UNITED STATES
NUCLEAR REGULATORY COMMISSION
WASHINGTON, D. C. 20555

These amendments revise the core protection safety limits, protective system maximum allowable setpoints, control rod position limits, operational power imbalance envelope and axial power shaping rod position limits for Unit 2 consistent with extending the duration of the Unit's present operating cycle from 297 ± 10 to 363 effective full power days. Editorial changes have been included as discussed and accepted by your staff.

SAFETY EVALUATION BY THE OFFICE OF NUCLEAR REACTOR REGULATION
SUPPORTING AMENDMENT NO. 78 TO FACILITY OPERATING LICENSE NO. DPR-38

OCONEE NUCLEAR STATION, UNITS NOS. 1, 2 AND 3

CORE PROTECTION
SAFETY LIMITS

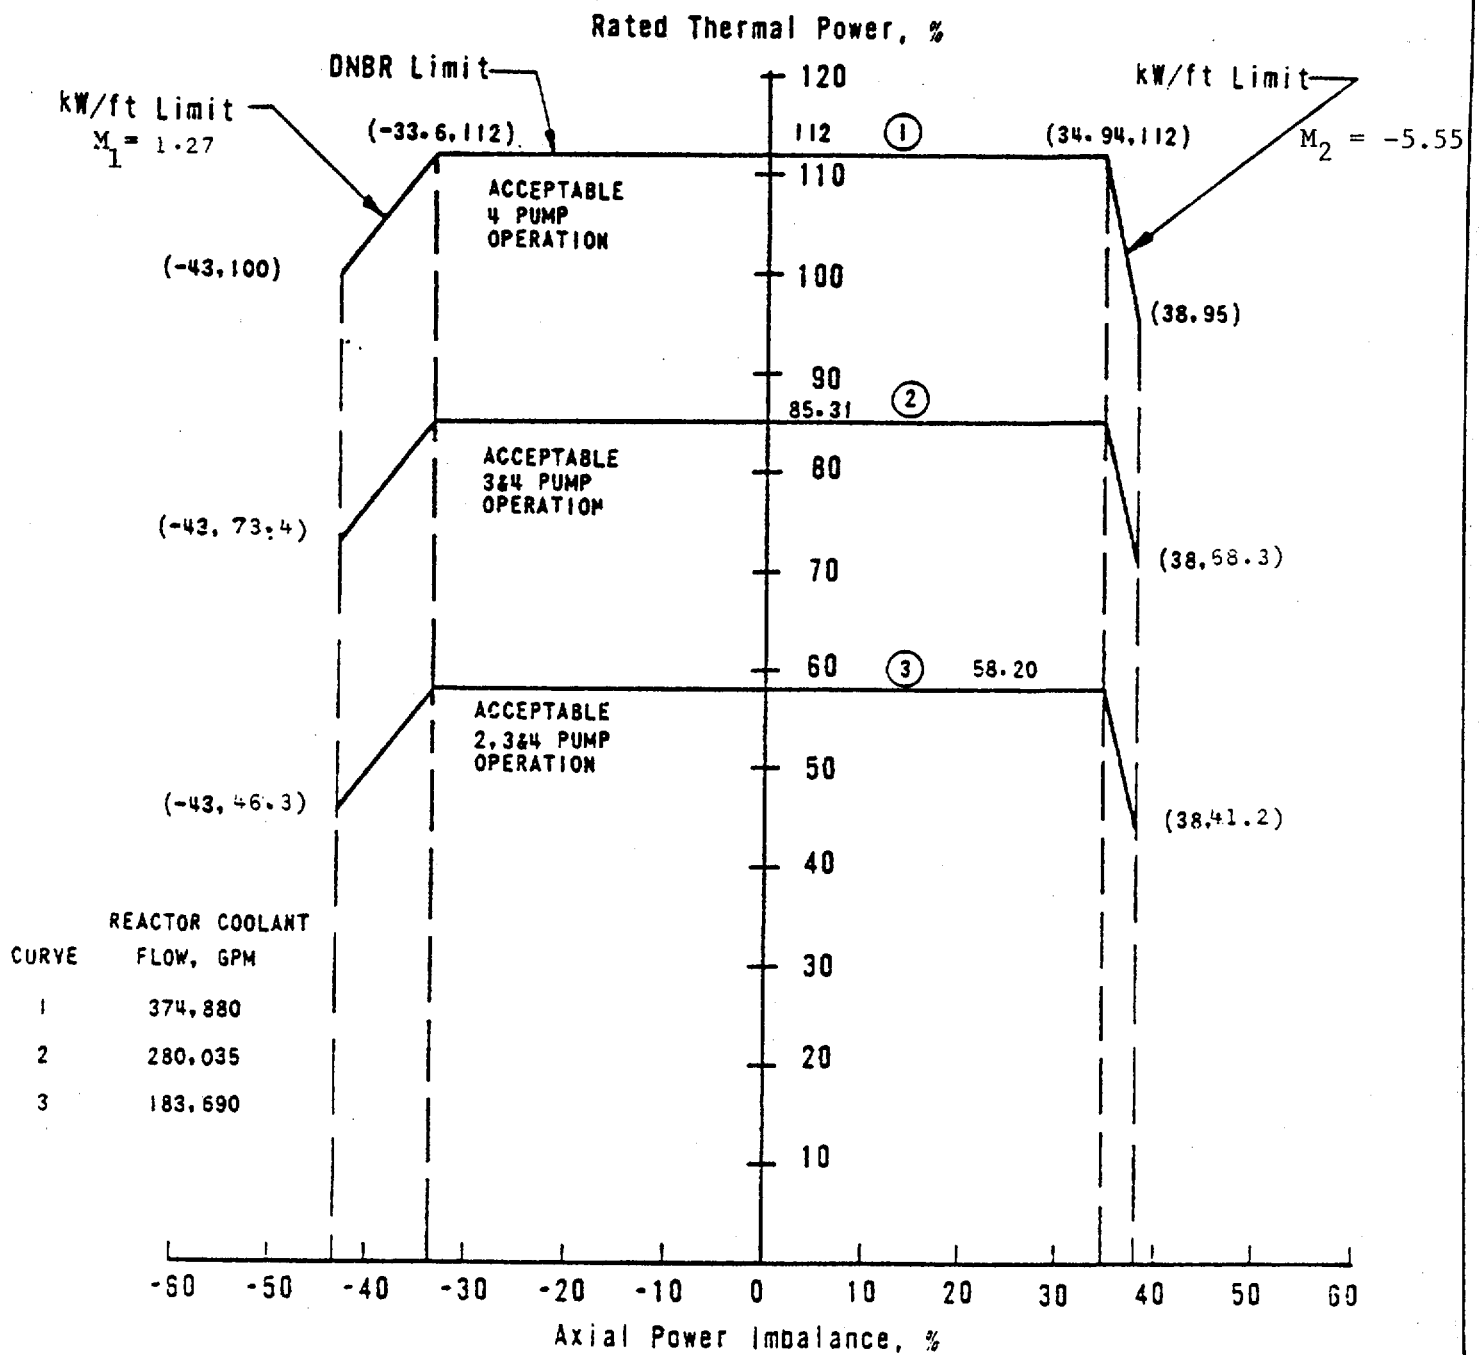
The TS would be revised to establish new reactor protection system limits and set points to ensure operation of the core within the prescribed DNB and accident limits such as peak clad temperature. The TS curves (which are acceptable) were derived following the methodology of B&W Topical Report BAW-10121 entitled RPS Limits and Set Points, June 1978.
